AGENDA
La Vergne Planning Commission
February 27, 2024 at 6:00 PM

Item Title: Site Plan - Blair Ridge - 141 Dwelling Units in 26 Buildings. Requested by SEC, Inc. Property located on Blair Road (Tax Map 29, Parcel 21.01). R-3 (High Density Residential) Zoning District. Property owned by 303B Partners. DEFERRED

Summary: On behalf of their client, SEC is requesting approval of the site plan for Blair Ridge, a townhome community.

1 Proposed Grading Plan
C-3.0 SCALE: 1" = 10'

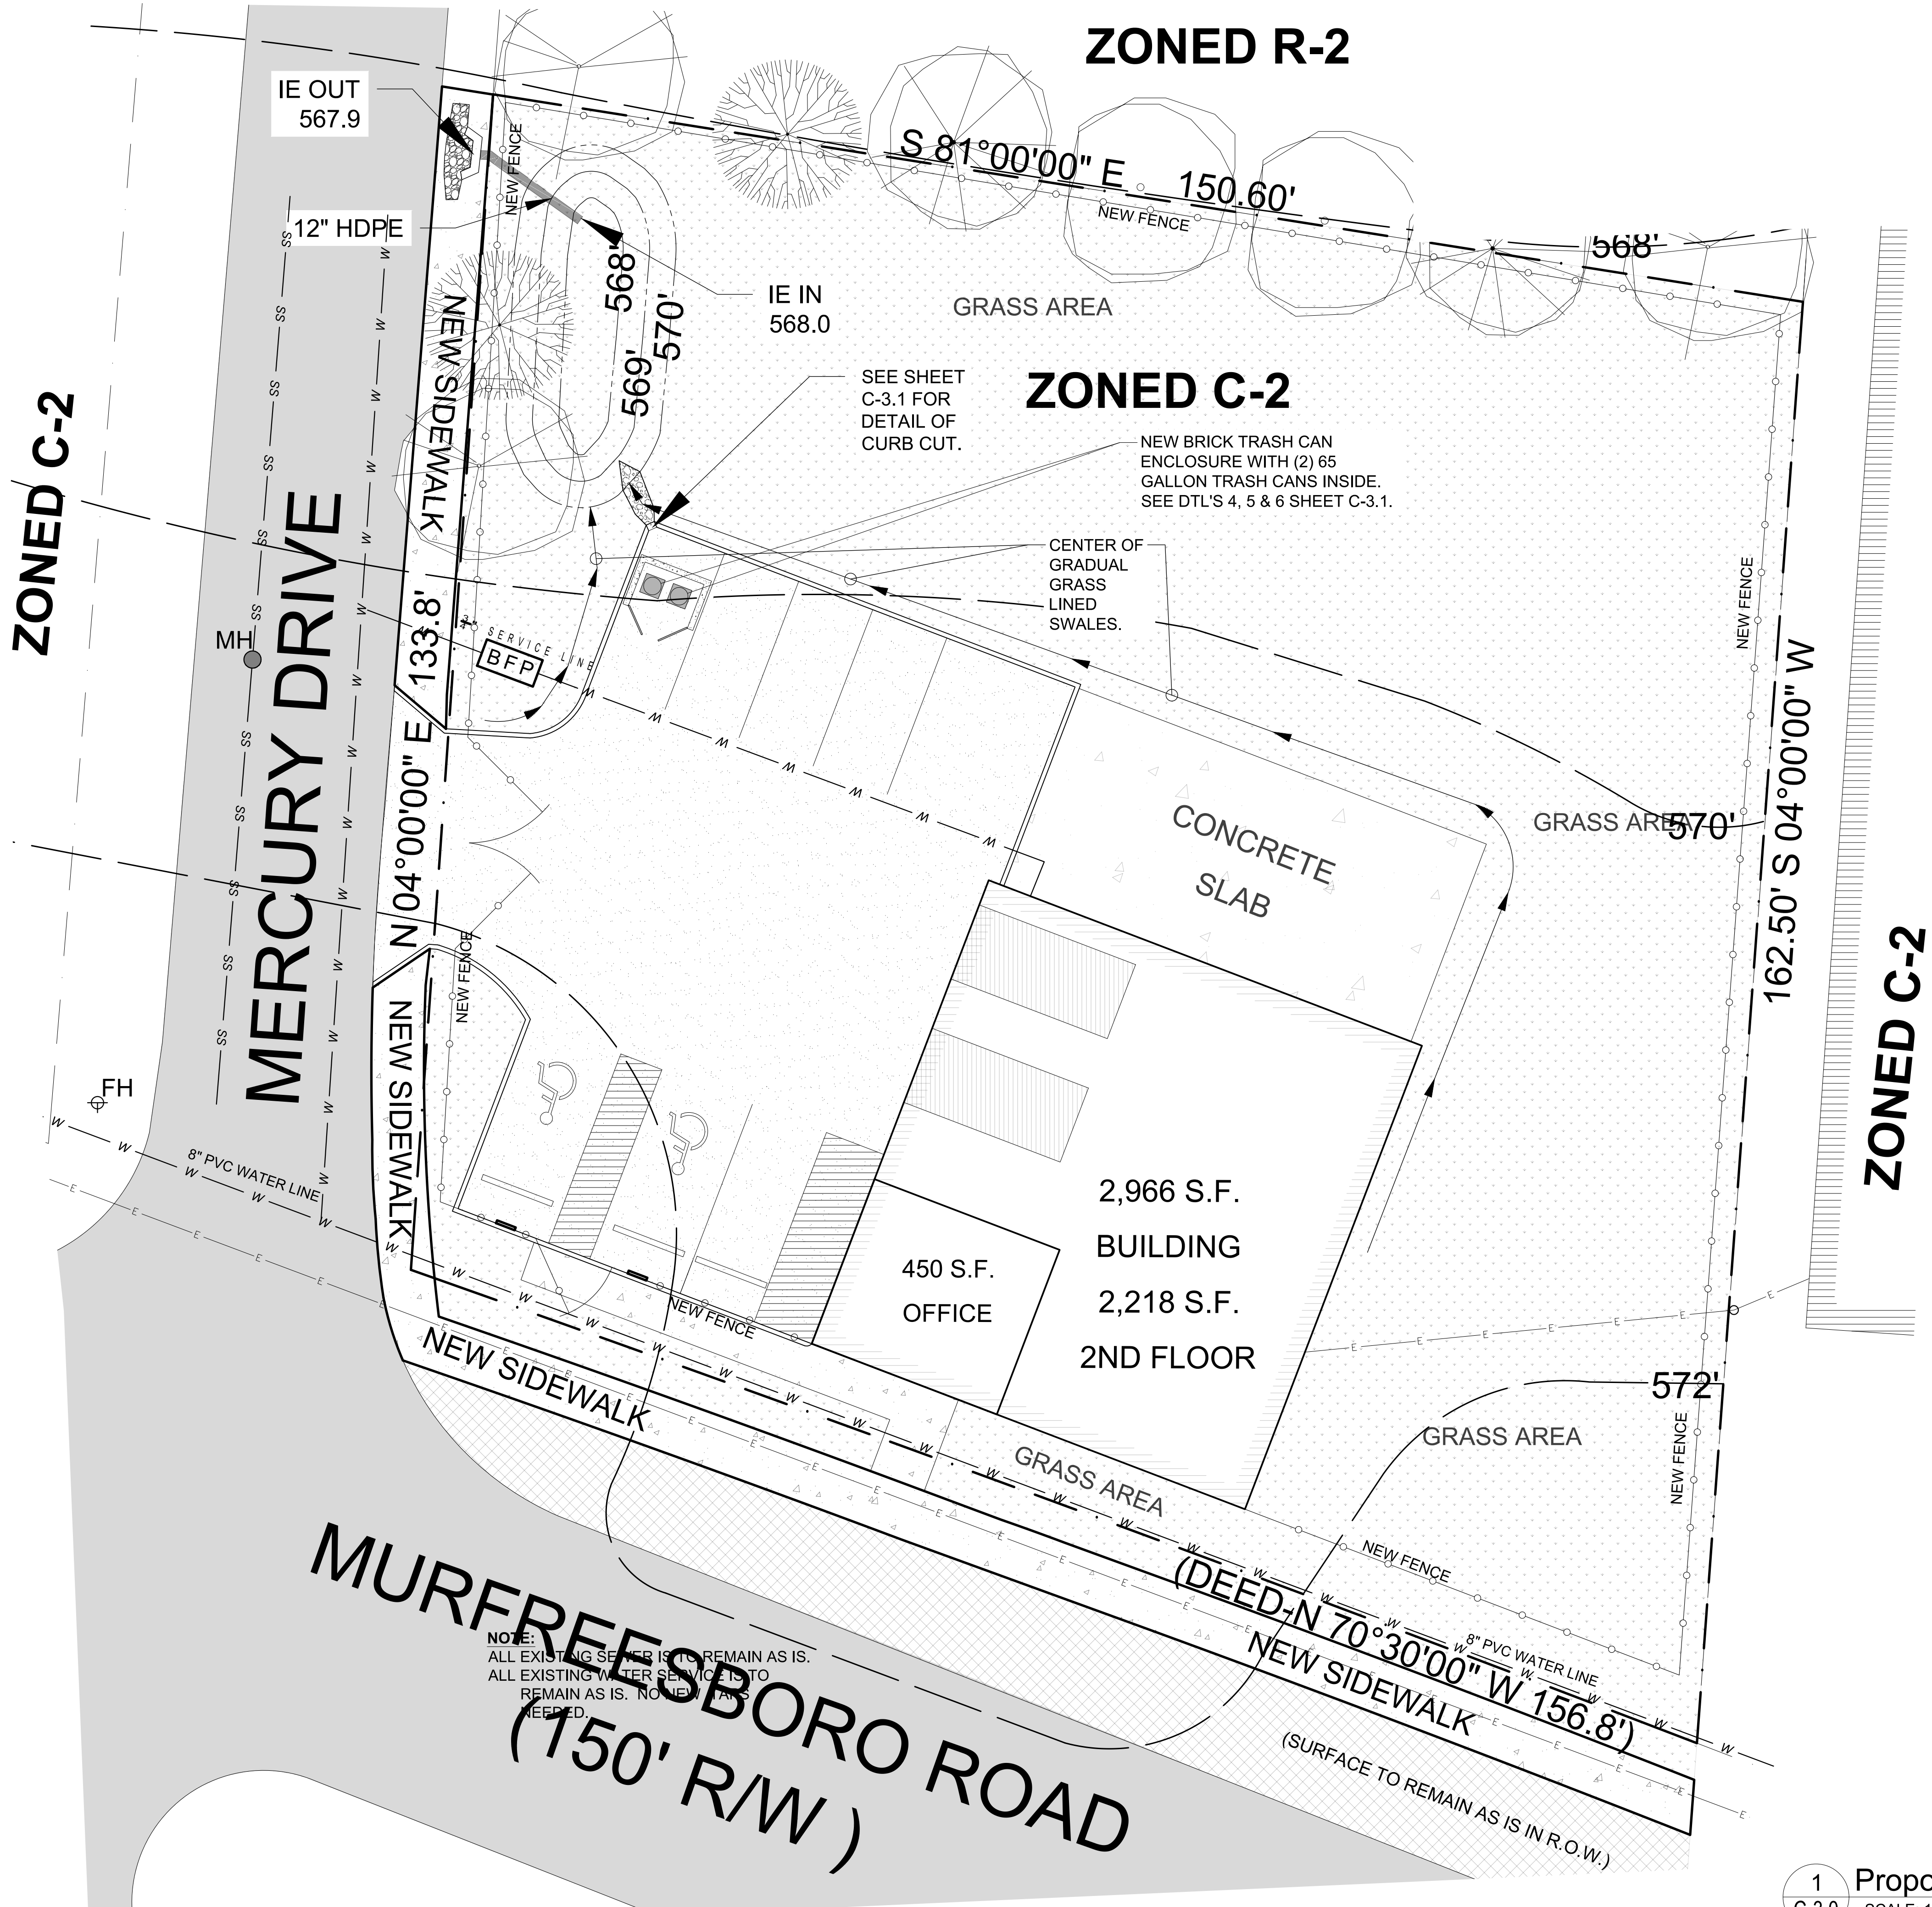
6. (C-3.0) Provide spot elevations along swale to confirm drainage slope.
7. (C-3.0) It is assumed that some work will be needed to rework the swale and direct all drainage into the detention basin per the original design. Provide erosion and sediment control and rename this sheet "Proposed Grading and EPSC Plan".
